TECHNICAL REVIEW COMMITTEE
FINAL RECORD OF DECISION AND ACTION ITEMS

SUBJECT: Diversion and Abandonment of Kirkwood #3 Lift Station to New Harvest Moon Lift Station (WBS Nos. R-000536-0021-3)

DRAFT TECHNICAL REVIEW COMMITTEE
DRAFT RECORD OF DECISION AND ACTION ITEMS
WBS No. R-000536-0021-3

Kirkwood #3 Lift Station (FN 340)
Alternative Route 2

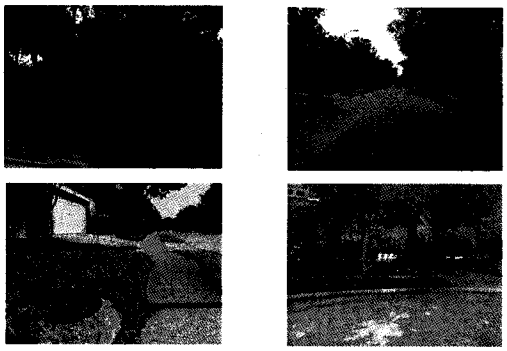
2. **The preferred option was stated as option /route 2, yet the exhibit furnished (item 8) suggests Route 1. Preferred "option 2 routes says mostly along streets and 1000 ft. on bayou bank, yet last page map (item 8) shows route mostly along southern bank of Buffalo Bayou, corresponding to route. The documentation should agree with recommendation. Verify what route is actually recommended. (BFSNC opposes route 1).**

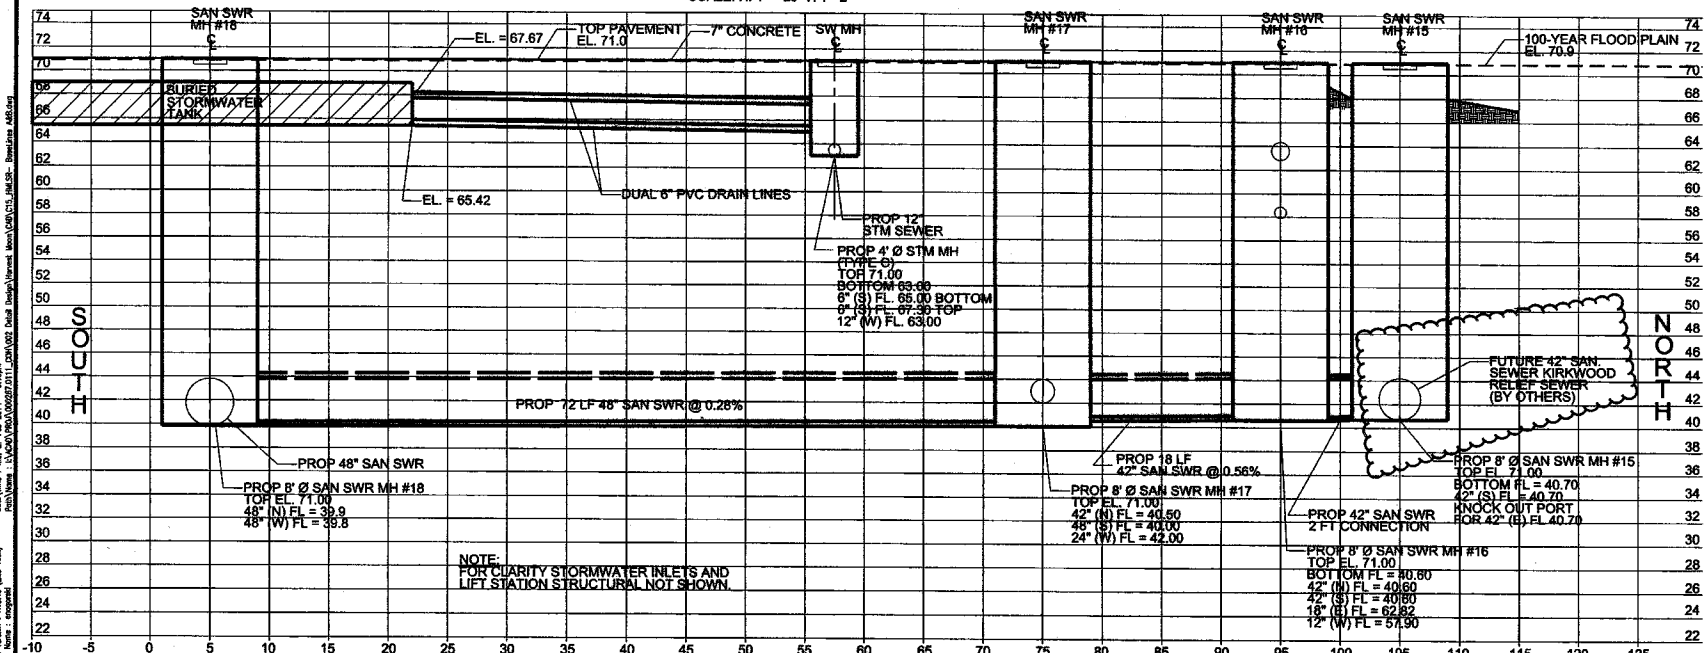
2. Provide a profile of the connection of the proposed 42" sewer line connecting to the new Harvest Moon LS.

Resolution: Completed and included with RDAI. (See attachment F)
Responsible party: ARCADIS
